Comments against HI-04-20: Historic Review of New Construction of two three-story mixed-use buildings within the Monteith National Register Historic District; 525 & 533 4th Avenue SW; 331 Calapooia Street SW.

Public Hearing Review of Historic Review of New Construction of two three-story mixed-use buildings within the Monteith National Register Historic District

RE: HI-04-20 Historic Review of New Construction

Height of Main Roof Peak with Abutting Properties

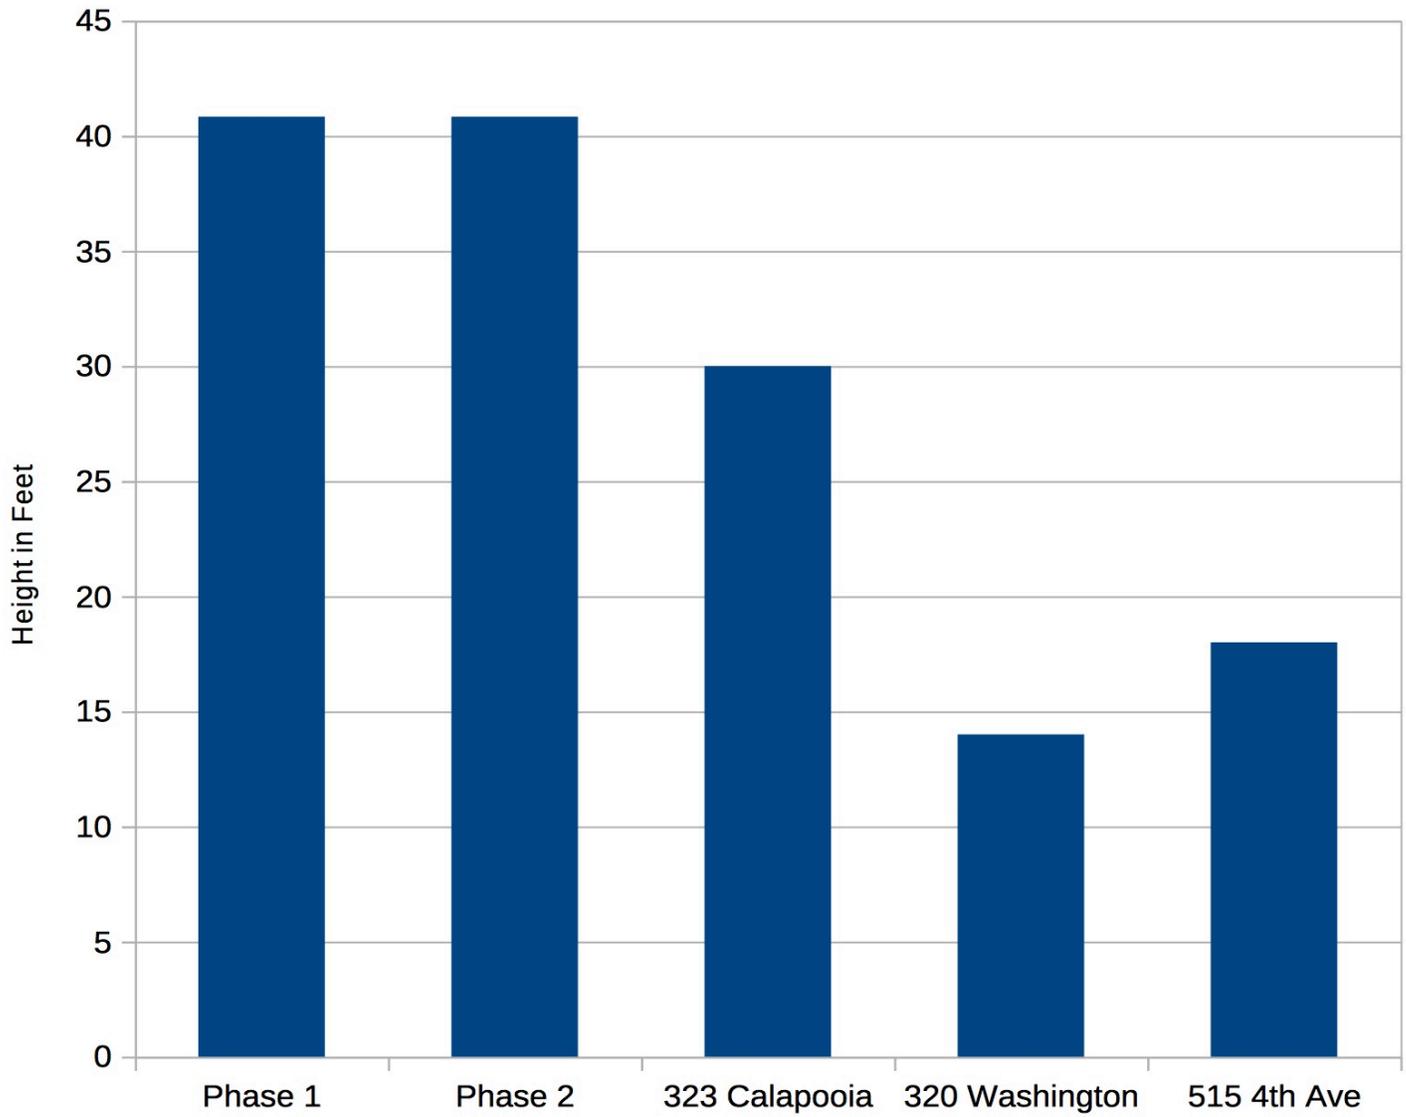
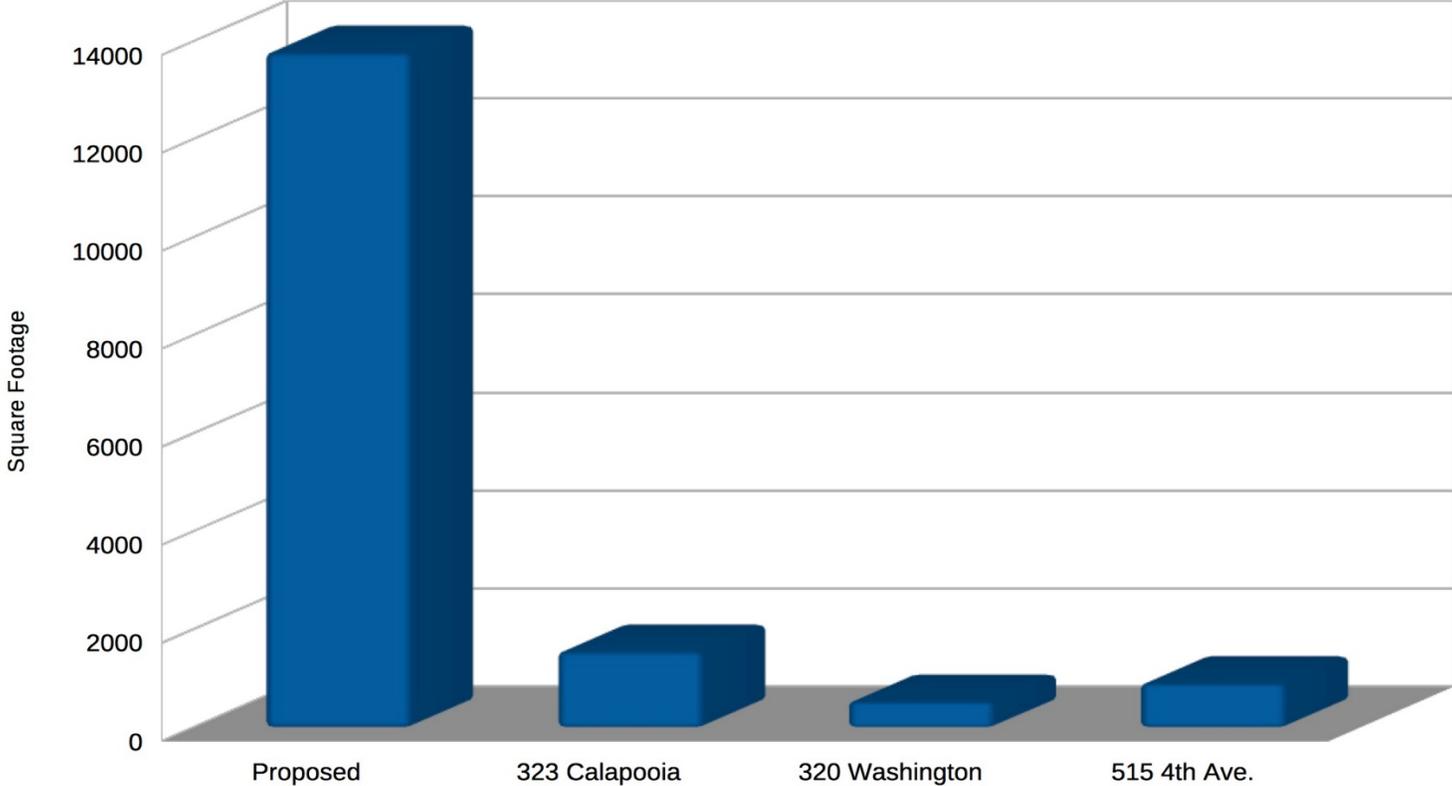
The pictures show the view from 41 feet (the height of the proposed edifices' roof line) looking in different directions from the corner of 4th and Calapooia, plus one photo taken from 41 feet near the east property line. Note how looking to the east you can even see over the top of the Fisher Funeral home, the Formiller Funeral Home, and the Downtown Library. Looking to the south and west, except for the Whitespears church tower, you are looking over the top of the entire historic district.

Also attached are graphs that show the main roof heights of the proposed structures compared to the abutting properties (as measured using my drone), and also the total square building footage of the proposed lot compared to the abutting lots.

Height of Main Roof Peak with Abutting Properties

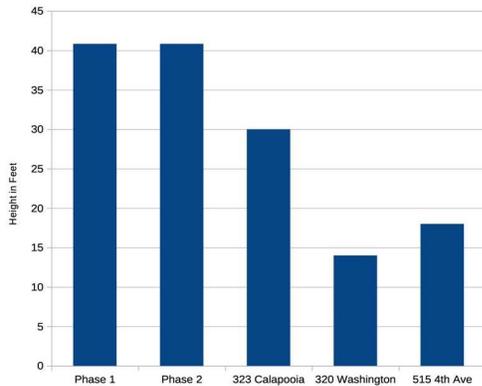
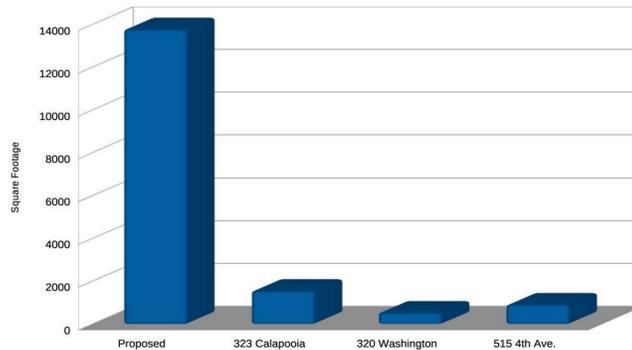
First lets talk about the height. 40' 10" towers over the neighborhood. Using a drone, I measured the heights of surrounding buildings; and 1 story structures ranged from 14 to 18 feet, and 2 story structures ranged from 26 to 30 feet to the main roof peak. Per the applicants own words, the original historic structures on this property were 28 feet high.

As shocking as the obscene height of the proposed building are, the sheer mass is even worse. Staff report says "In comparison with the abutting historic contributing single-family residential dwellings to the north and east, the proposed structures are approximately twice as wide and seven times as big." Indeed, the total combines square footage of the 4 proposed buildings is 13,774 square feet. Thirteen-thousand-seven-hundred-seventy-four square feet! This is outrageously incompatible.
